SUBJECT: REQUEST FOR ADDITIONAL INFORMATION FOR THE MODEL NO. OUTER
PACK-RAW MATERIAL SHIPPING CONTAINER, REVISION 0 – (EPID NO.
L-2020-NEW-0008)

Docket No. 71-9387
EPID No. L-2020-NEW-0008

Request for Additional Information
Docket No. 71-9387
Model No. Outer Pack-Raw Material Shipping Container

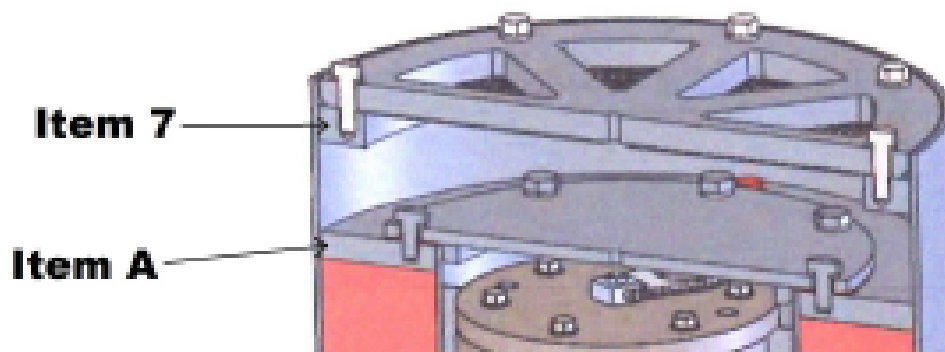
1.1. Provide component dimensions.

SAR Drawing OP-RMSC-SAR-TA, page 1 of 4 identifies seven stainless steel plates used to fabricate the Outer Pack-Raw Material Shipping Container (OP-RMSC). Based on staff's review of the drawings, two of the seven steel plates have both an outer diameter and an inner diameter. However, staff only identified one steel plate (i.e., Item 7) with both an inner and an outer diameter listed on drawing OP-RMSC-SAR-TA, page 1 of 4. Since the steel plate in question is also numbered incorrectly on OP-RMSC-SAR-TA, page 2 of 4 (see RAI 1.2), staff has identified the plate in question as "Item A" in the figure below. Staff needs this information to ensure correct fabrication of the package.

This information is necessary to satisfy the requirements in 10 CFR 71.33(a)(5).
